AIRWORTHINESS DIRECTIVE

Powered sailplanes fitted with Rotax 505 engines
Serial No. 3332.580 to 3332.689

Inspection/replacement of cylinder holding down studs.

GFA AD 308	Issue 1
24/9/1986	Sheet 2 of 6

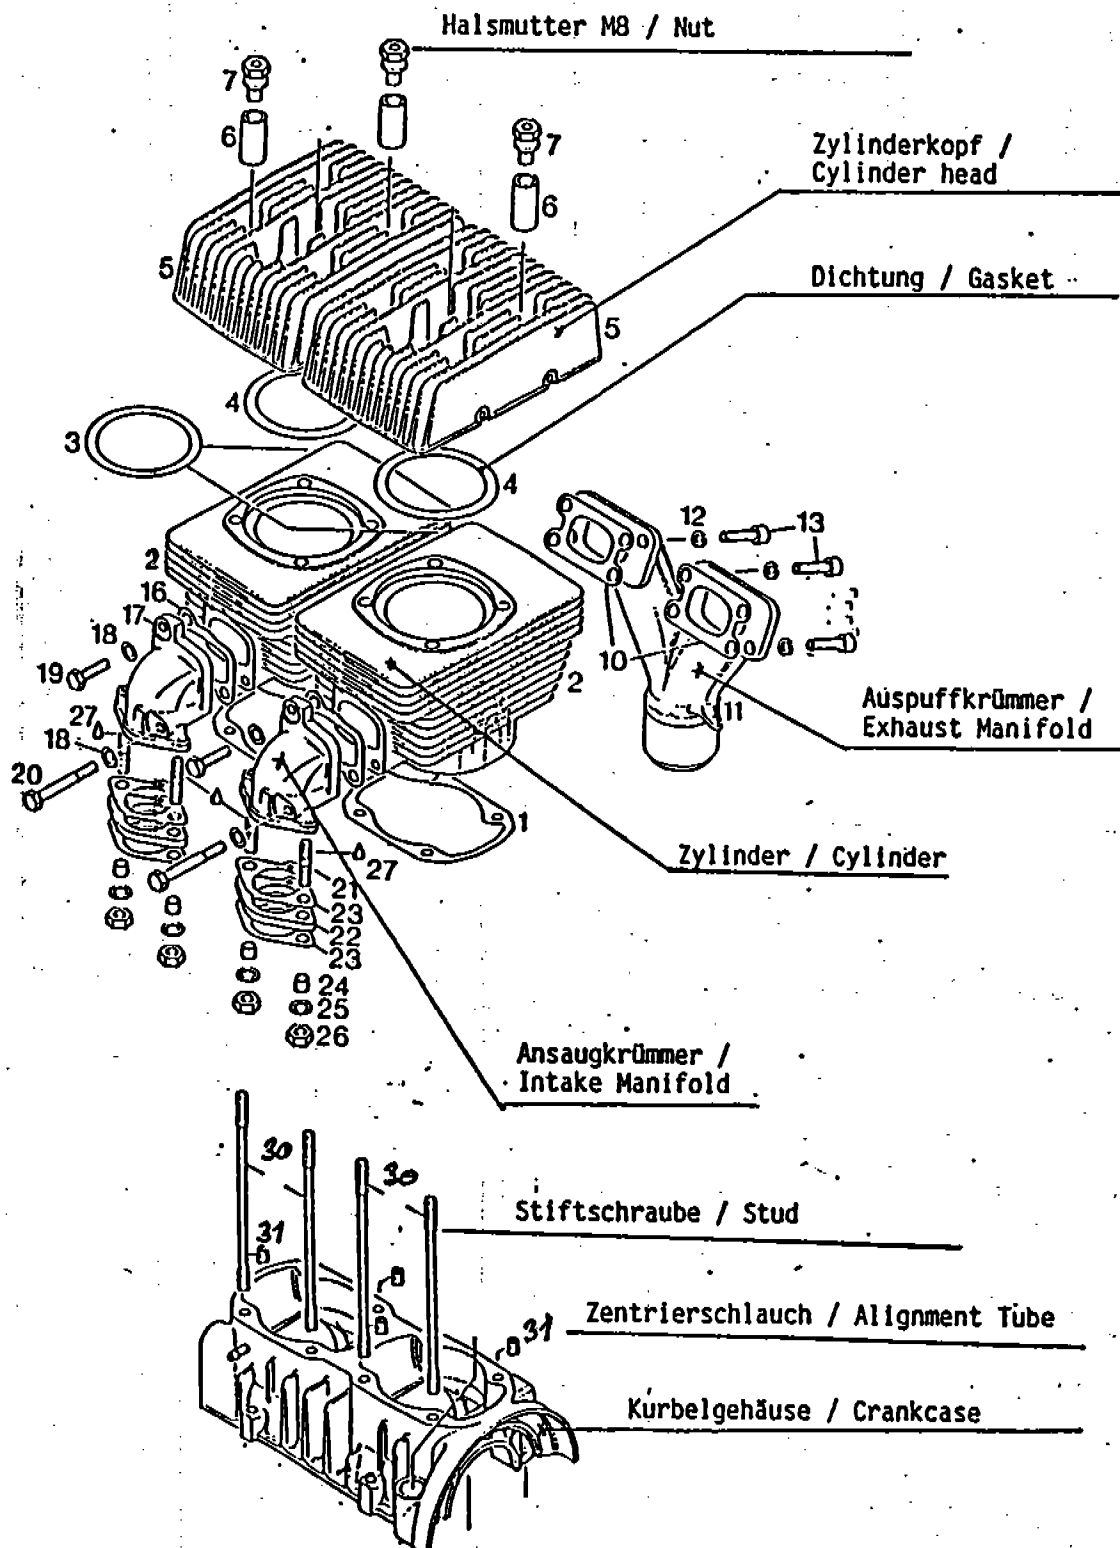
Subject : Studs 840 585 (M8 x 177) connecting cylinders to crankcase (8x).

Reason : Breakage of studs.

1) Checking the studs:

First indication of broken studs are signs of oilleaks between cylinder and cylinder head. If the socket nuts are also used for suspension purpose or the nuts are not accessible, request and pay attention to advises of aircraft manufacturer.

2) In case of any broken studs you must not start engine anymore.

3) Exchange of studs 840 585 according to following instruction.

: 8x stud 840 585
4x alignment tube 974 521
2x cylinder head gasket 831 880

TECHNICAL NOTE No. 505-01	Page 2 of 3
<p><u>Instruction for exchange of the 8 studs connecting cylinders to crankcase</u></p>		
<ol style="list-style-type: none"> 1) Remove socketnuts item 7 (see illustr. on page 3) diagonally and remove spacers (item 6). 2) Take off cylinder head, keep cylinders in position. 3) Remove cylinder head gaskets and if present, compression shims. Don't reuse gaskets, always exchange for new ones. 4) Carefully remove carbon deposits from top of piston and combustion chamber. 5) Exchange studs (item 30) diagonally across. <p><u>Attention:</u> Insert alignment tubes (2 per cylinder, positioned diagonally). Fit studs with shorter threaded end right to bottom of tapped blind hole.</p> 6) Refit cylinder heads, using new gaskets. <p><u>Attention:</u> Fit nuts and compensating washers in same position as prior to disassembly.</p> <p>Tighten socketnuts diagonally with 20 Nm.</p> 7) In case of stud breakage remove any remaining parts from the tapped hole in the crankcase.
